**ADDENDUM # 3**  
**Grass Valley School District**  
**District Support Services Building**  
**Gilmore Way, Grass Valley CA**

**Clarifications:**

Sheet Number	M1.1
-----------------	------

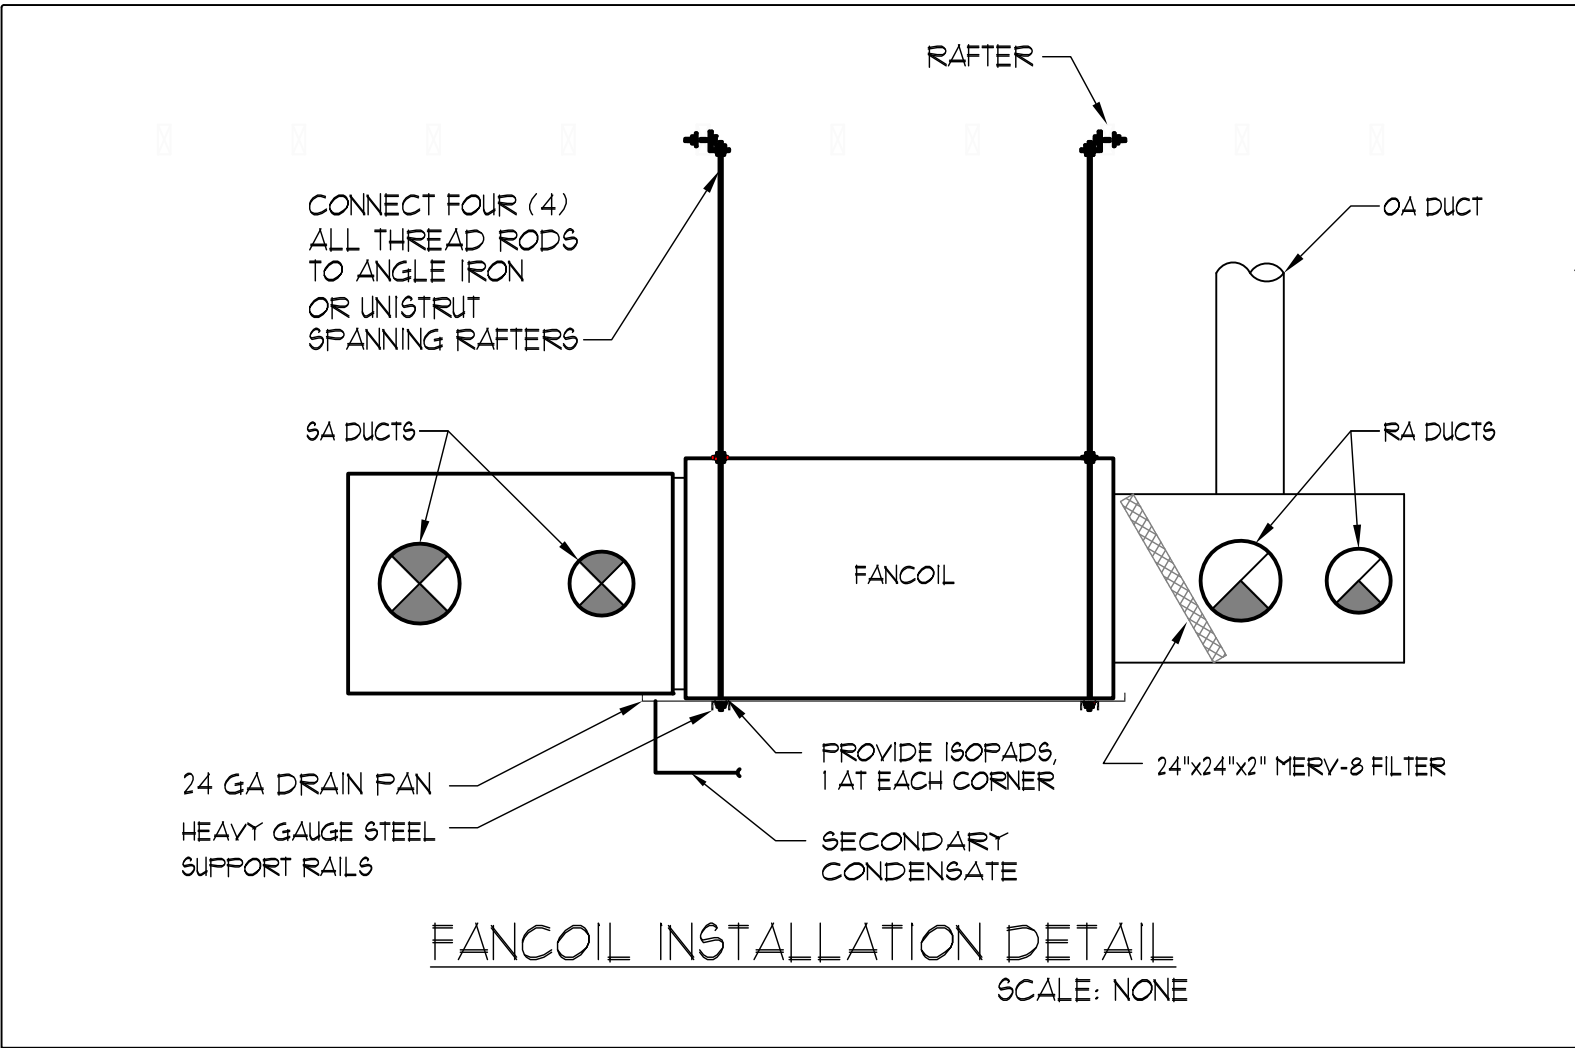
1. A small heat pump unit has been added to serve the “IT Storage Room”, see attached sheets M0.1, M1.1.
